**DOCUMENT 00 90 00  
ADDENDUM**

**ADDENDUM NO. [1]                      Date: February 19, 2018**

**RE:                      MEDFORD AREA PUBLIC SCHOOL DISTRICT  
ATHLETIC COMPLEX IMPROVEMENTS  
1015 WEST BROADWAY  
MEDFORD, WISCONSIN 54451  
HSR PROJECT NO. 17067**

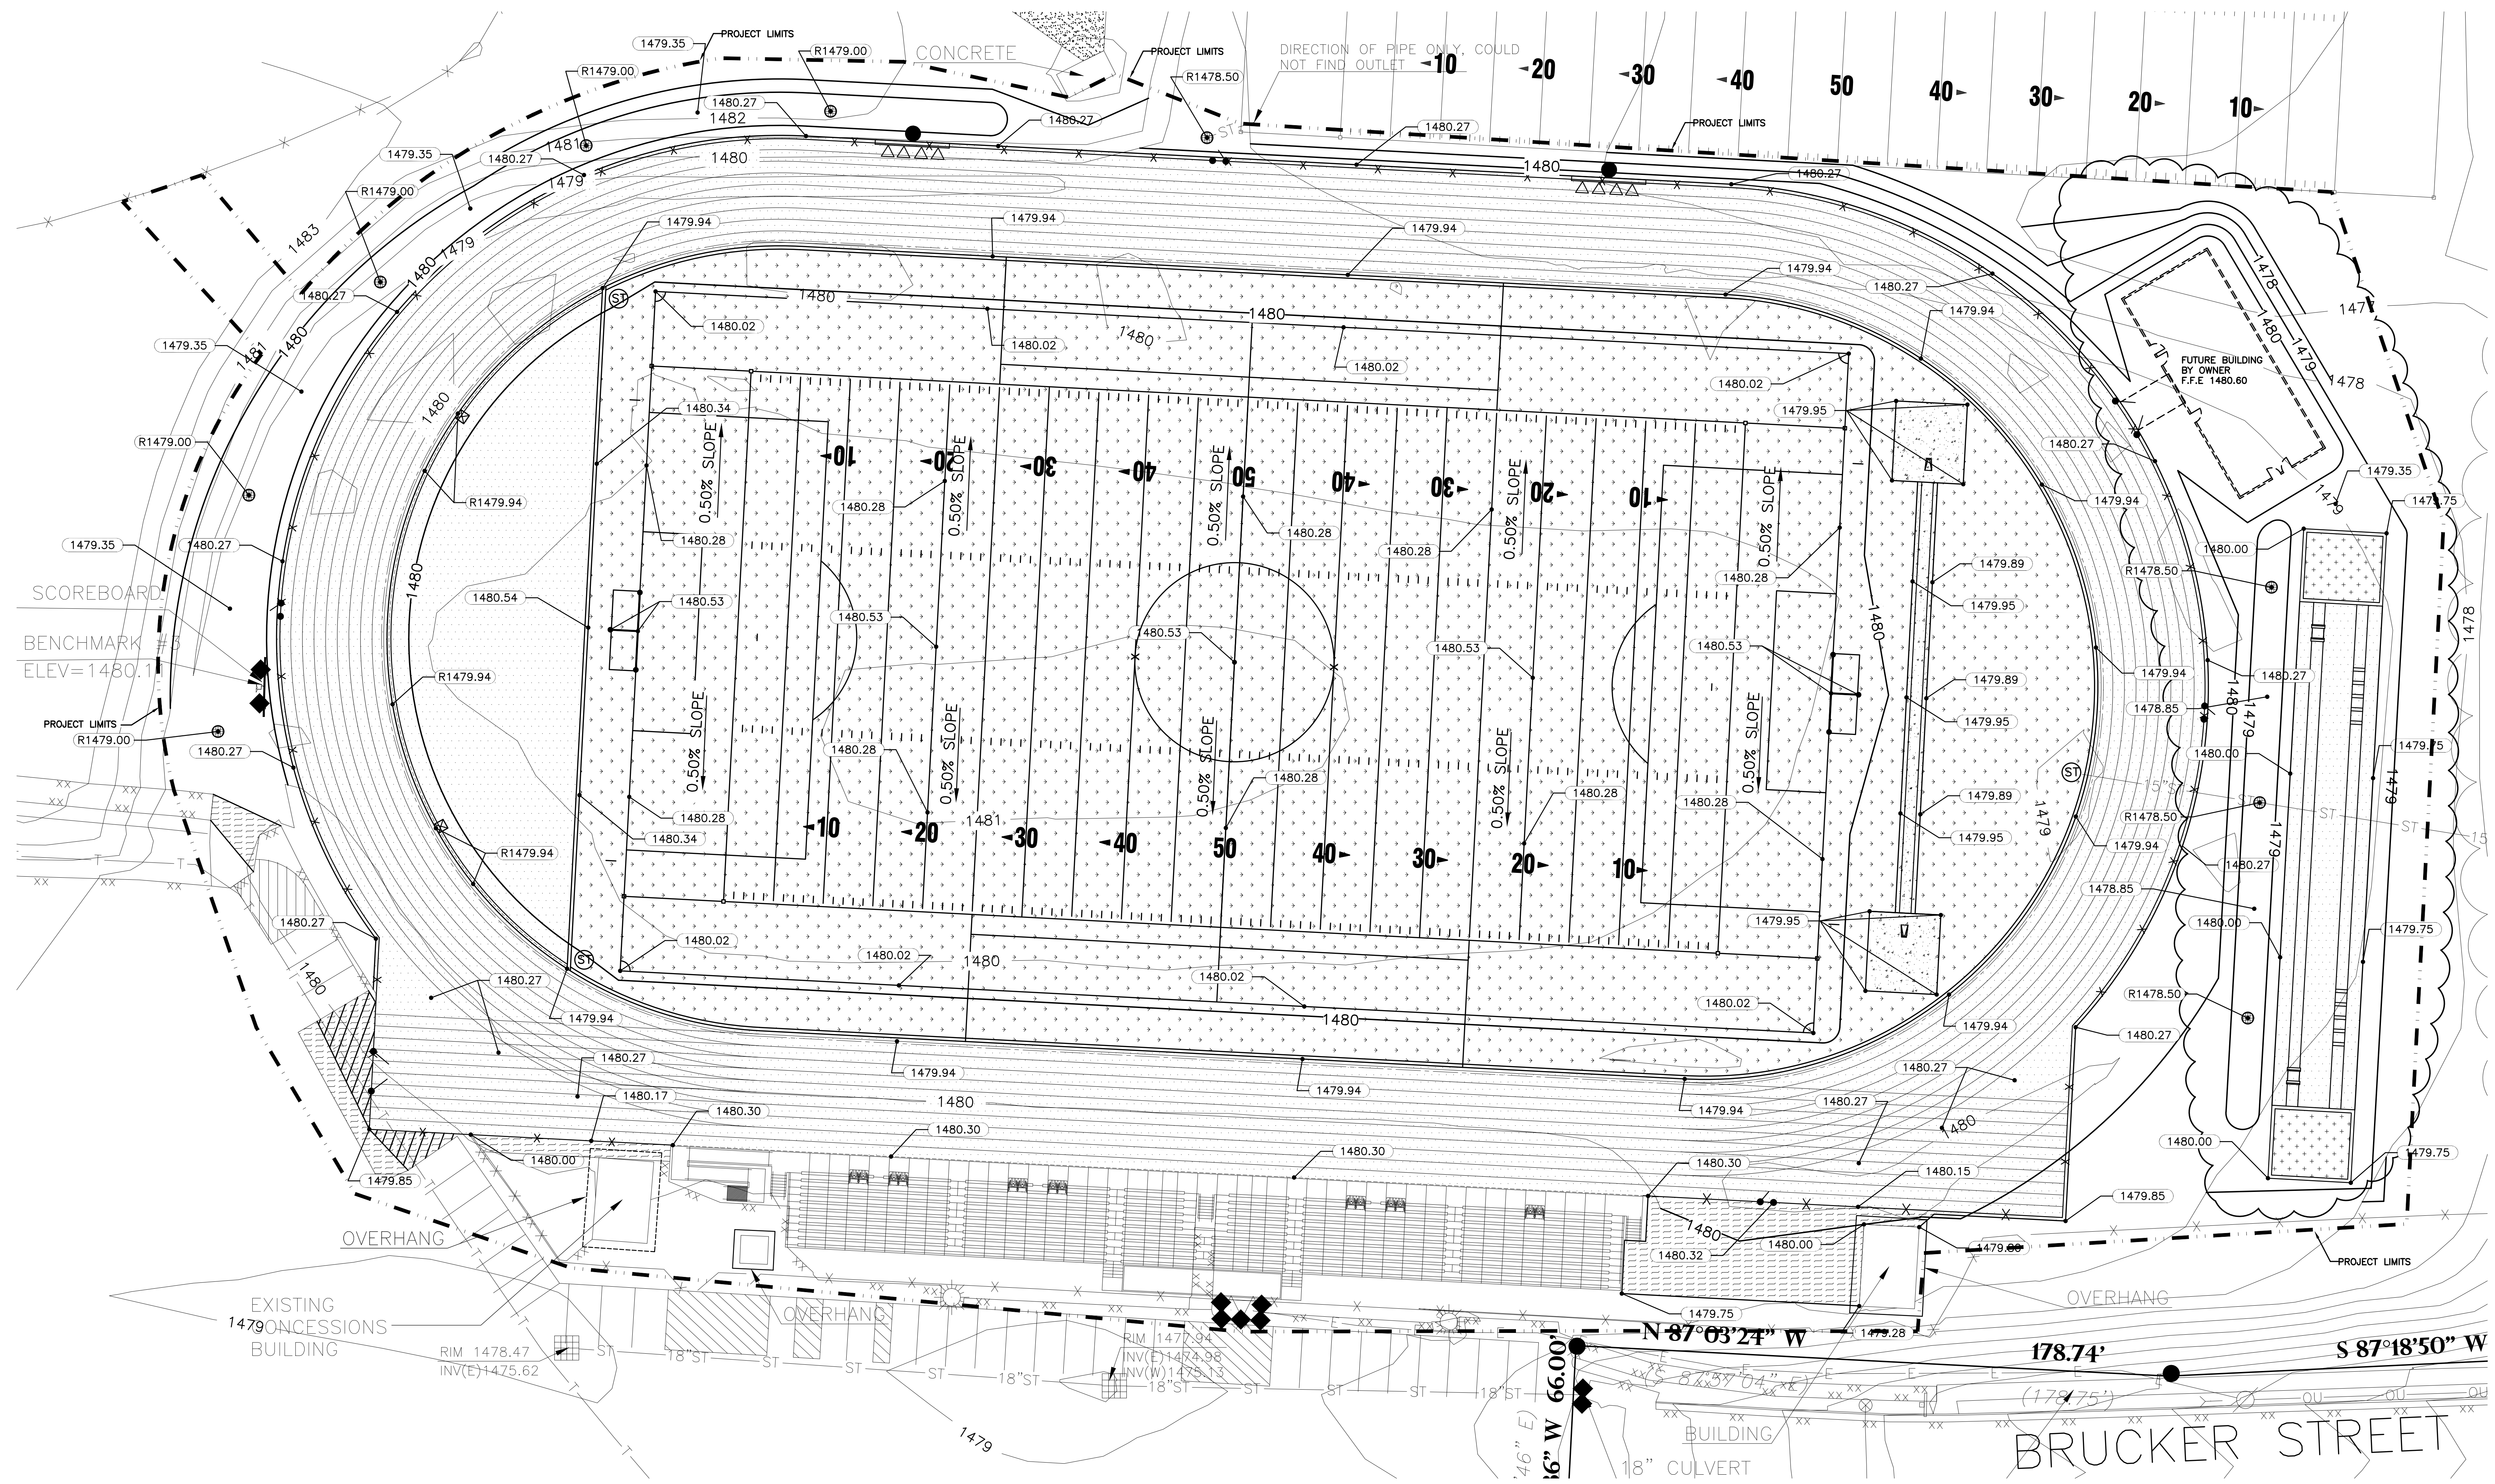
- d. Install new 12' wide double service gate at the NE corner of track for access to the future storage building constructed by owner.
10. Sheet C104R: SITE GRADING PLAN 30 x 42 attached hereto

- a. Revise finish grade elevations at proposed long jump area.
  - b. Grade to fill area NE of proposed running track for future storage building constructed by owner.

**C105R**

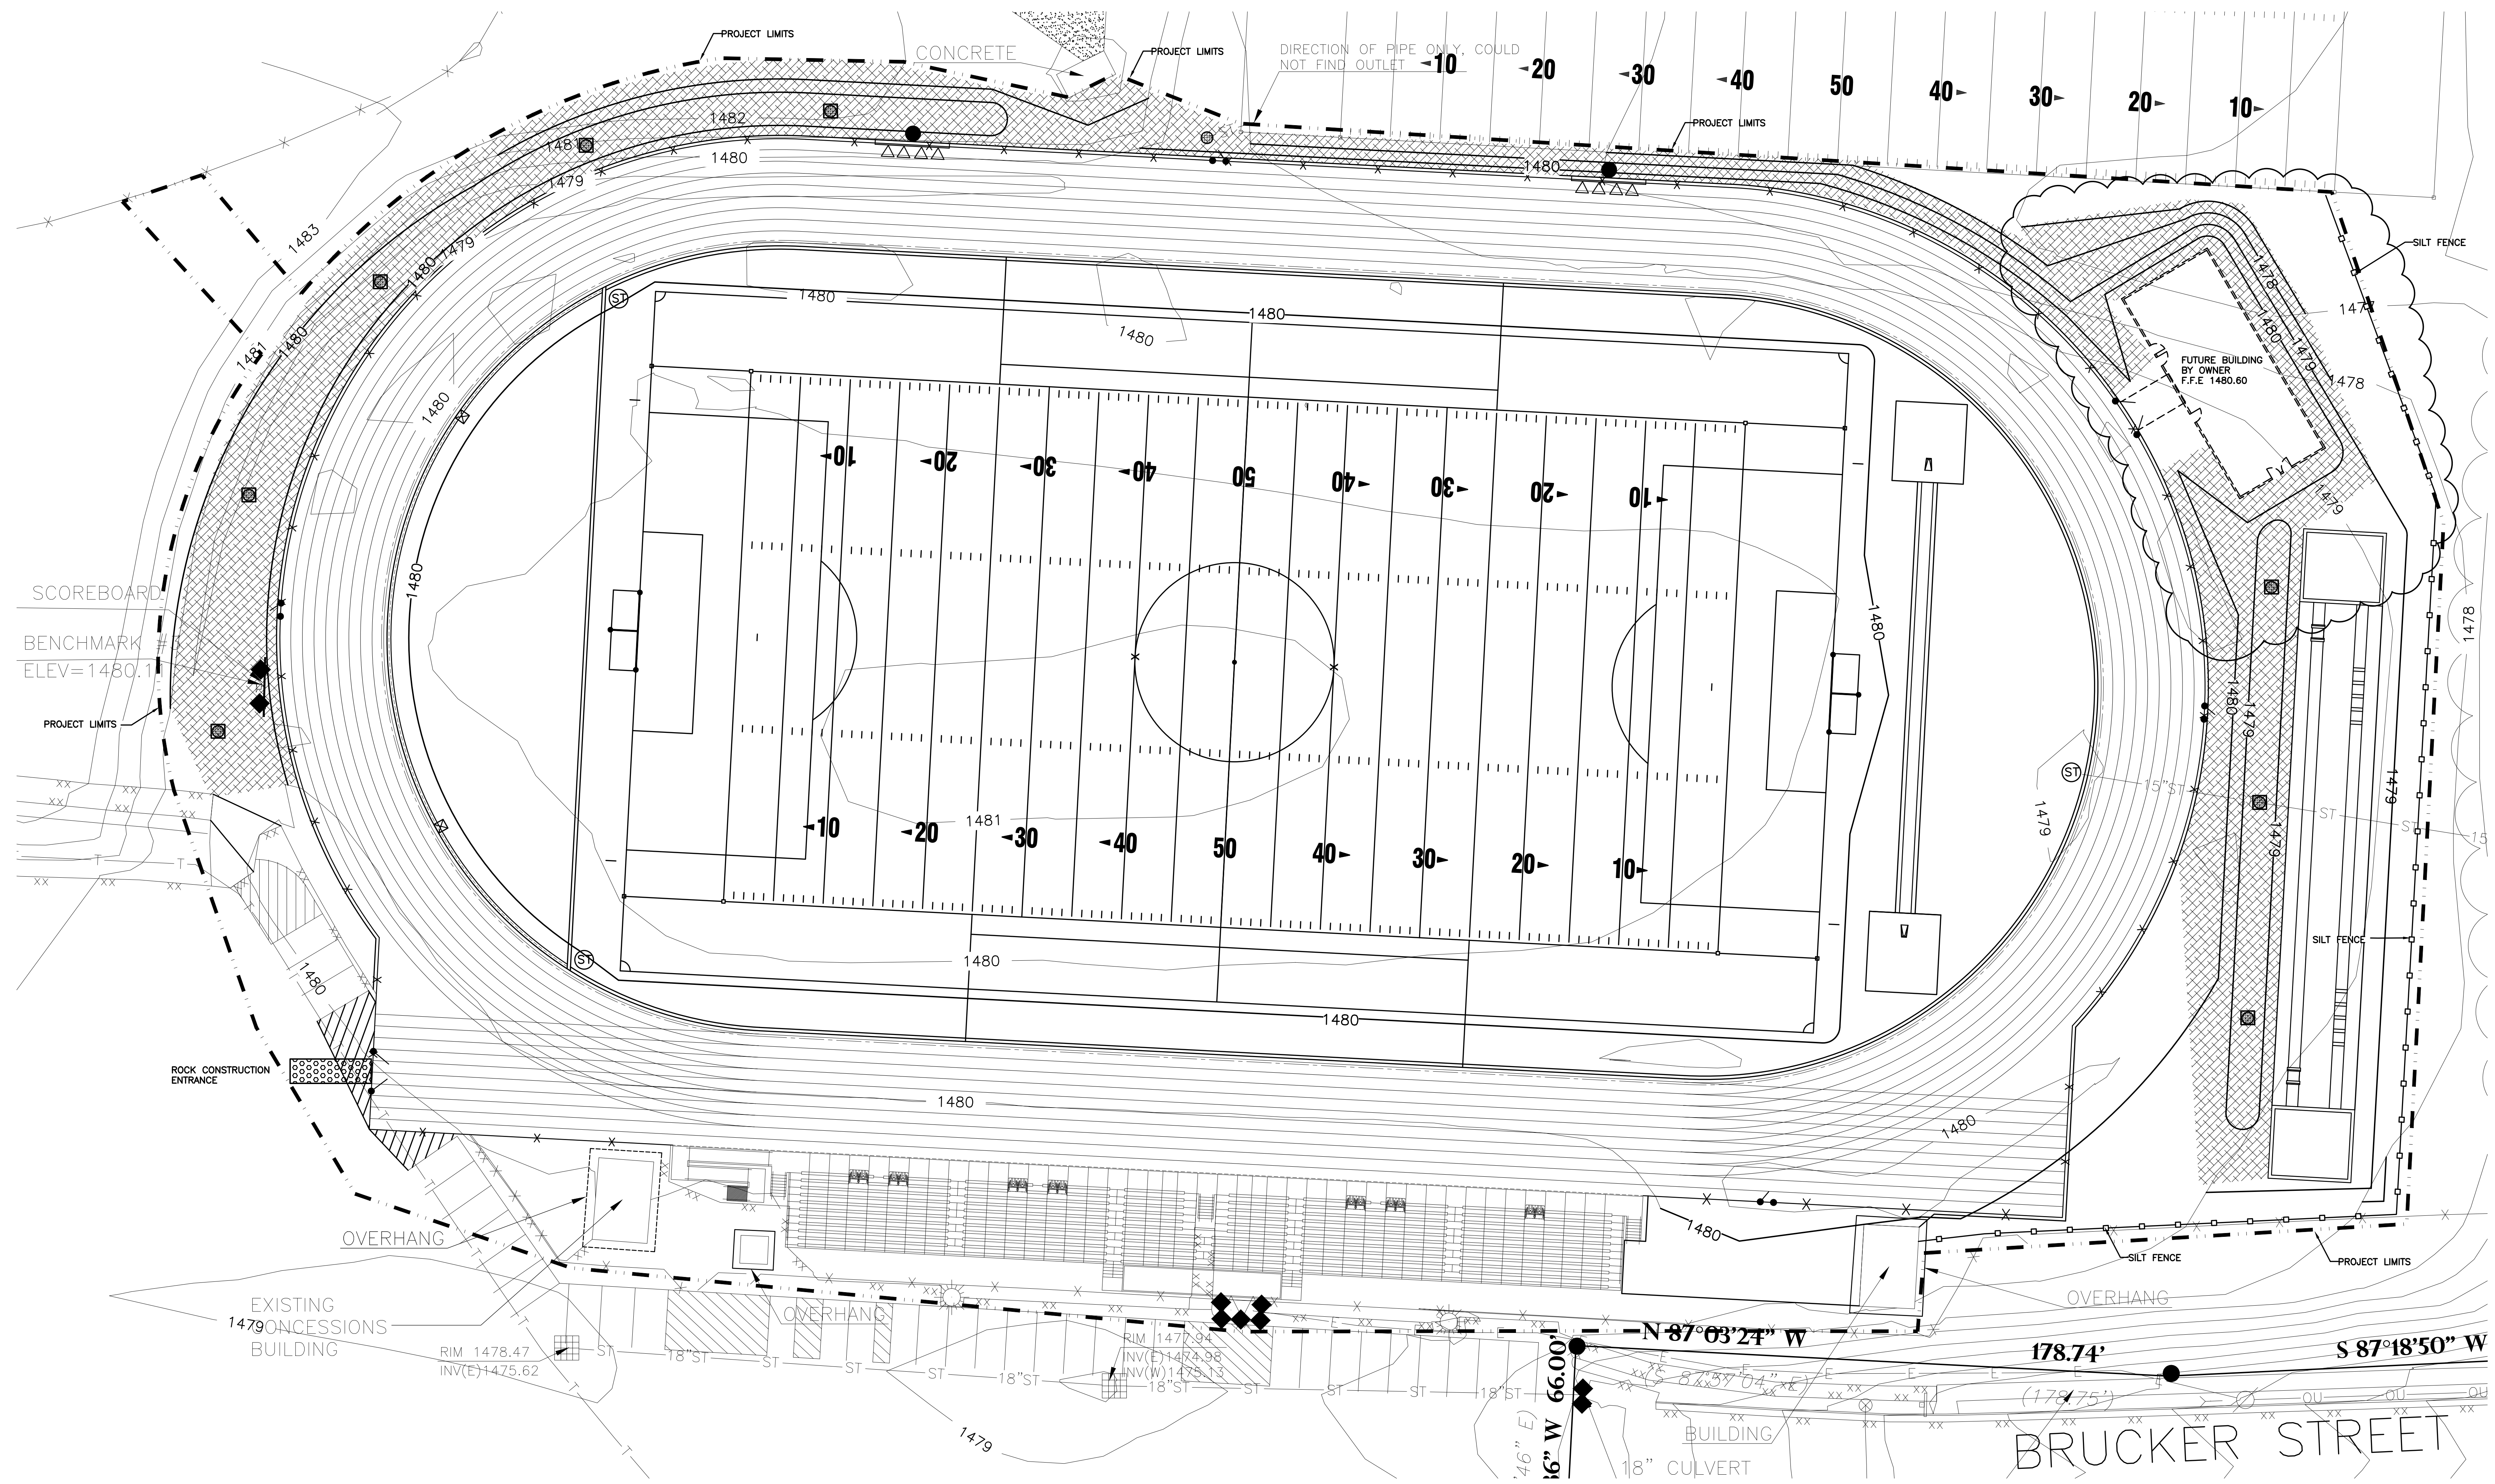
11. Sheet C105R: SITE EROSION CONTROL PLAN 30 x 42 attached hereto
  - a. Install additional erosion control blankets at NE corner of proposed running track for storage building pad area.

C106R

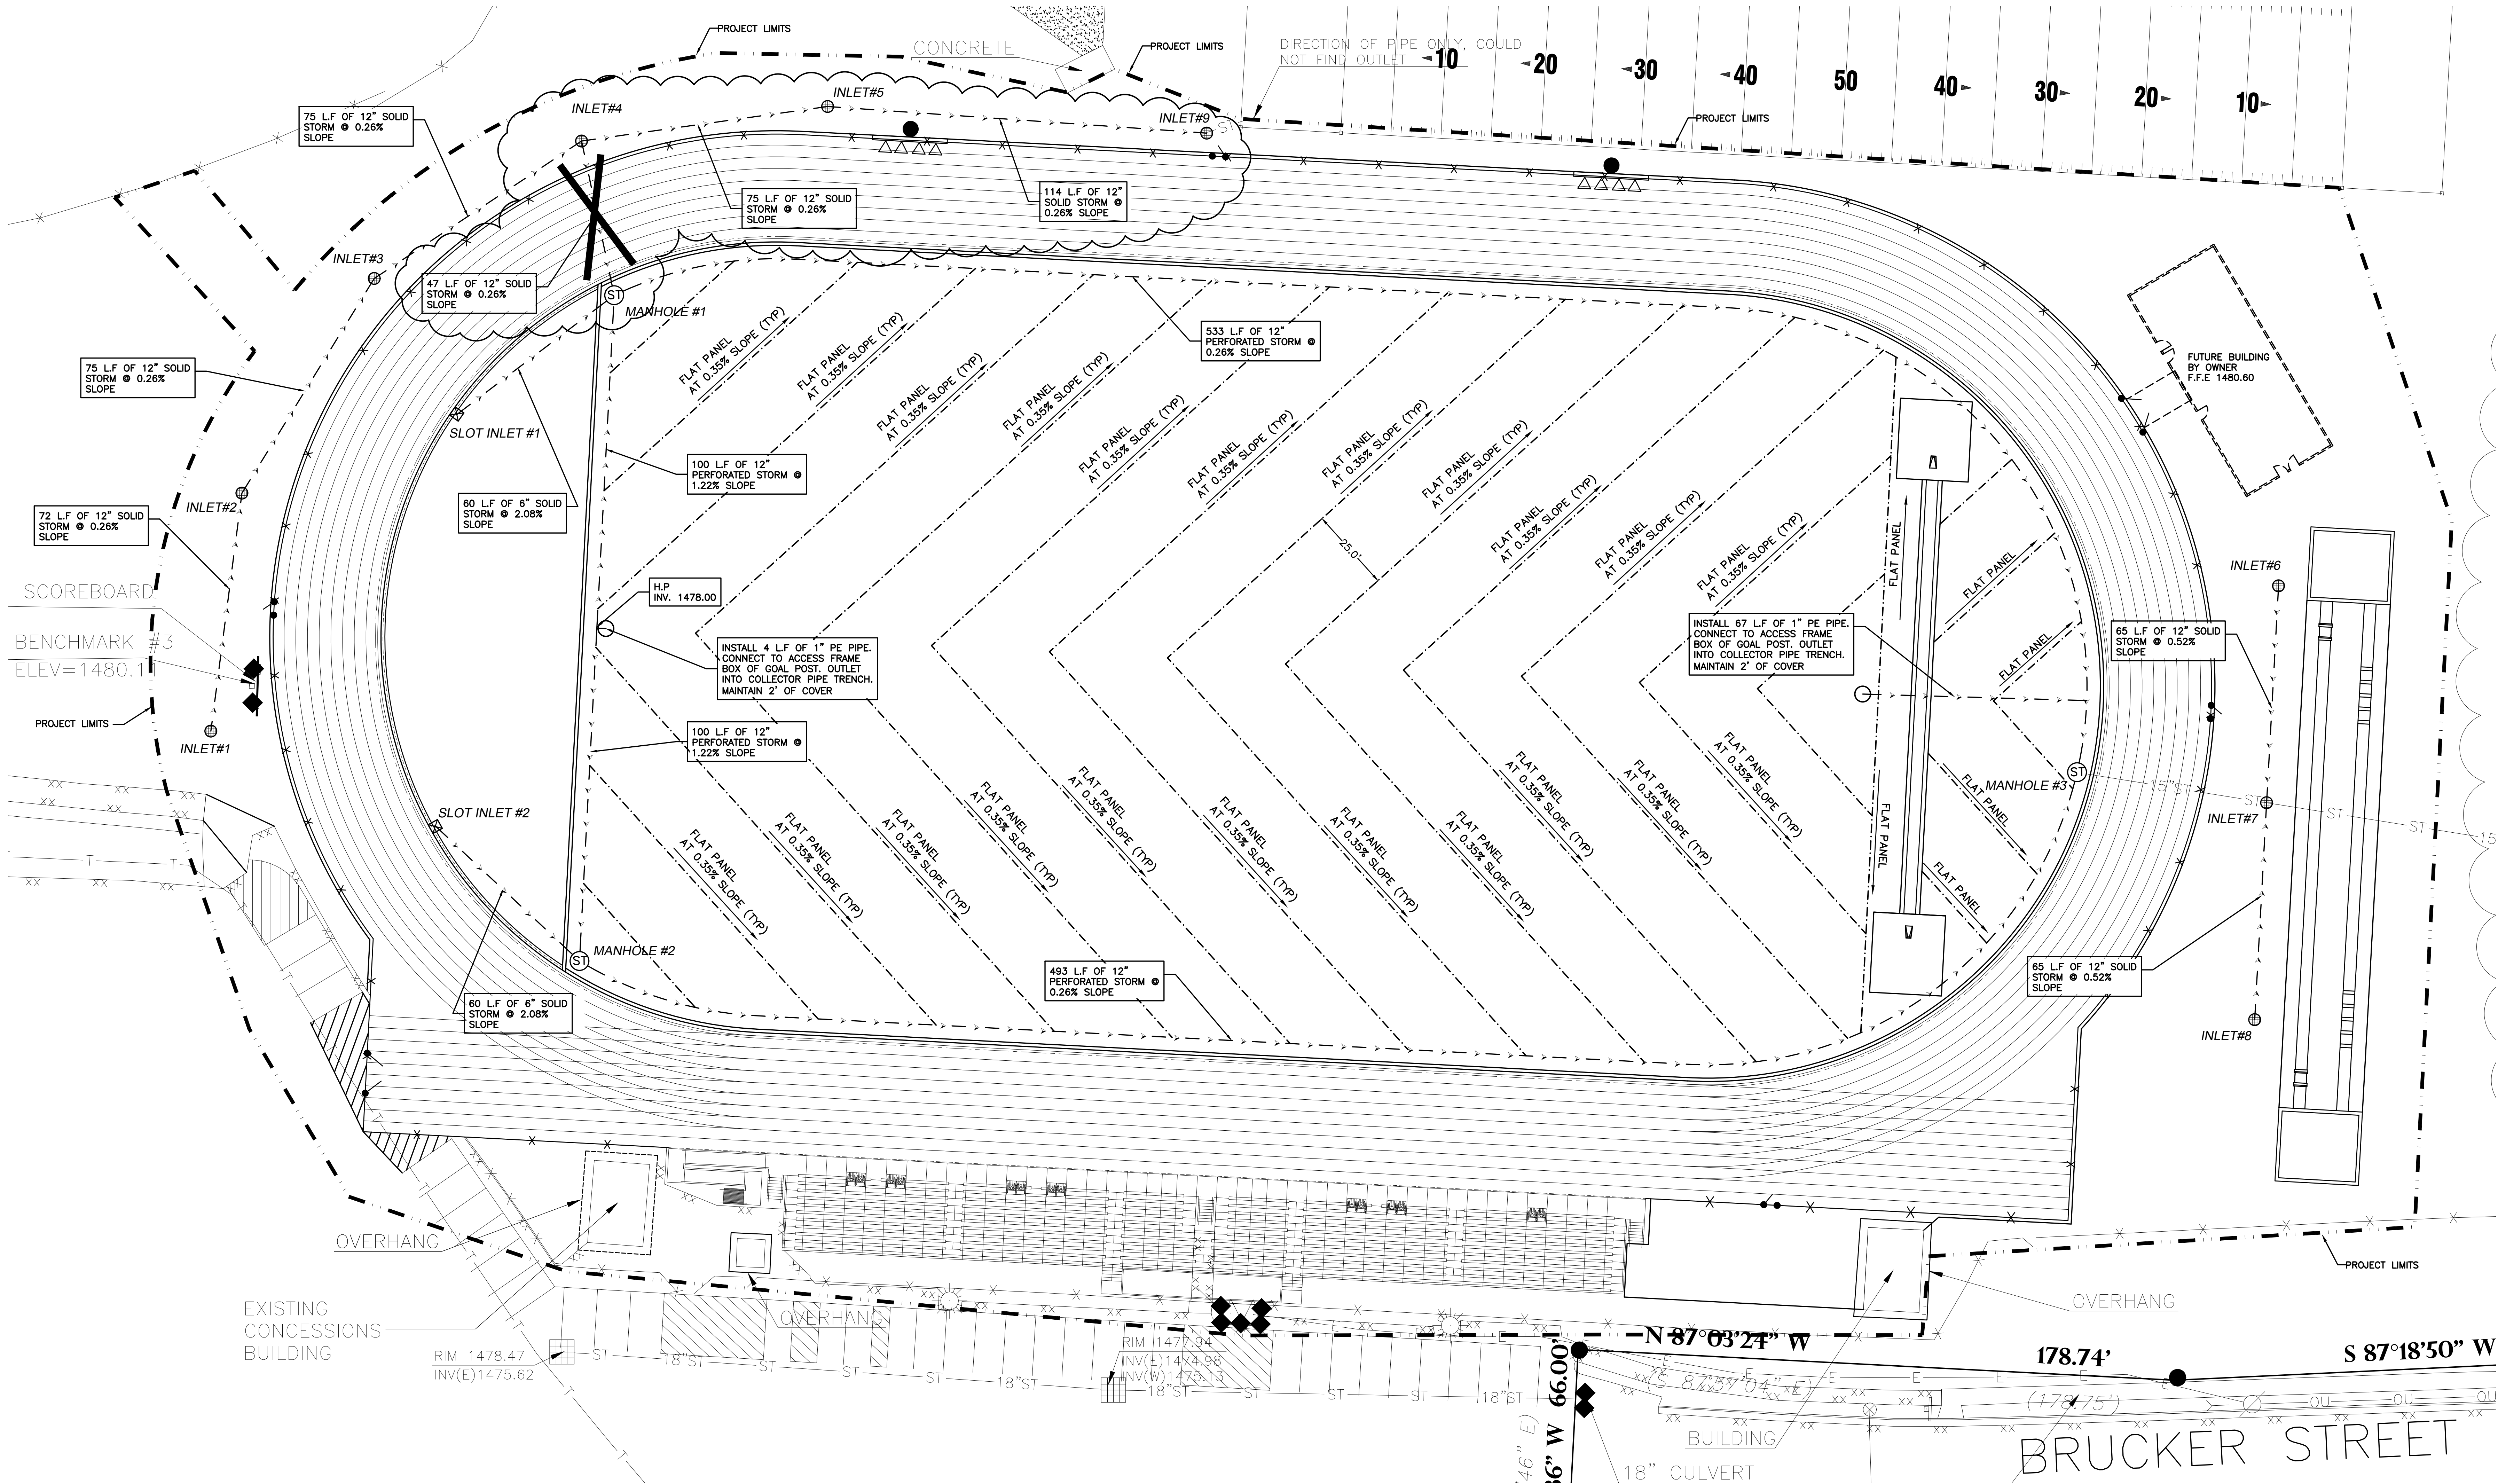
12. Sheet C106R: SITE STORM SEWER PLAN 30 x 42 attached hereto
  - a. Omit 47 L.F of 12" storm pipe connecting Inlet #4 to Manhole #1.
  - b. Revise proposed Inlet #5 elevations.

- c. Install new Inlet #9 at existing west practice field edge along with 114 L.F of new 12" storm pipe.
